MIL-C-39029/31B
AMENDMENT 1
19 September 2002

MILITARY SPECIFICATION SHEET

CONTACTS, ELECTRICAL CONNECTOR, PIN, CRIMP REMOVABLE,
(FOR MIL-C-26482 SERIES I, MIL-C-26500 AND MIL-C-26518 CONNECTORS)

This amendment forms a part of MIL-C-39029/31B, dated 25 April 1980, and is approved for use by all Departments and Agencies of the Department of Defense.

Figure 1: Add:

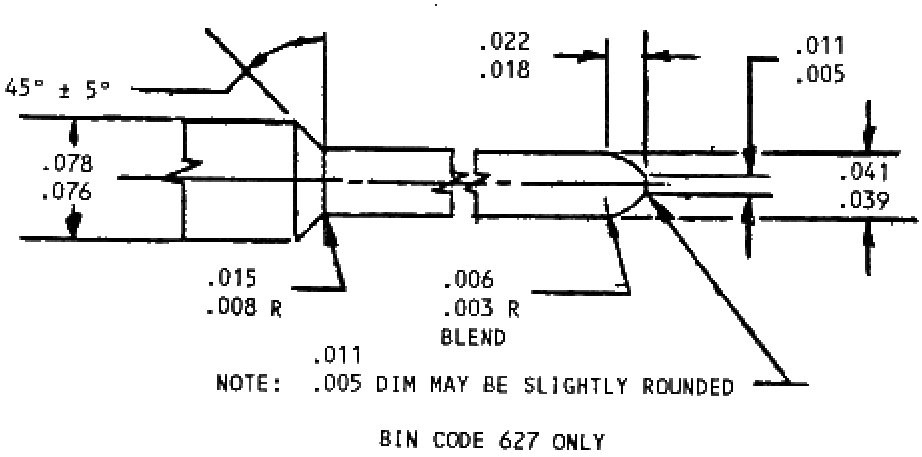
Figure 1: Table I, Bin code column, fourth row, after 448: Add 627.

Figure 1: Notes: Add: 8. For dimensions of tapered pin, bin code 627, see figure 1 drawing.
